SUBJECT: Confirms commitments for compliance w/ATWS rule 10CFR50.62 re recirculating pump trip, per 890303 telcon.

Subject: NUCLEAR PLANT NO. 2
OPERATING LICENSE NPF-21
PROVISIONS FOR ATWS
RECIRCULATING PUMP TRIP

WNP-2

ATWS/RPT Coincident Logic

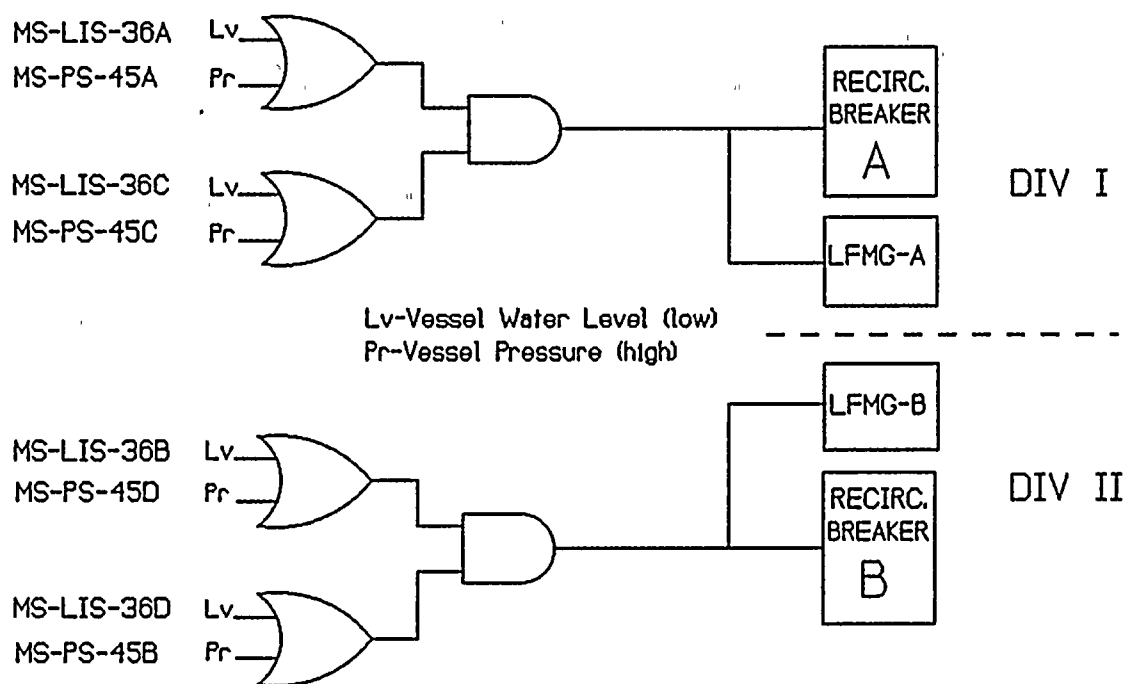
- o The Supply System will redesign the WNP-2 RPT logic trip scheme.
- o This redesign will include the ability to test the logic and controls of the system up to, but not including, the final actuation device while at power.
- o Attached is the Supply System's conceptual design for the redesigned RPT logic trip scheme. Since this redesign effort requires considerable time for the detailed design, procurement, installation and acceptance testing of the system, we request that the Staff provide the Supply System with any concerns they may have with our conceptual design no later than April 21, 1989. Absent any such comments, the Supply System intends to proceed with this effort on that date.
- o The ATWS RPT System will be modified to incorporate these changes during our 1990 Spring outage.

The proposed coincident ATWS/RPT logic is designed to trip both Recirculation Pumps and trip both low frequency Motor Generator sets during an ATWS event but prevent inadvertent trips. In addition, the logic is designed to be tested during Plant Operations up to the final actuating device prior to the breaker trip coils. Also, this design does not present electrical separation concerns between Division I and Division II.
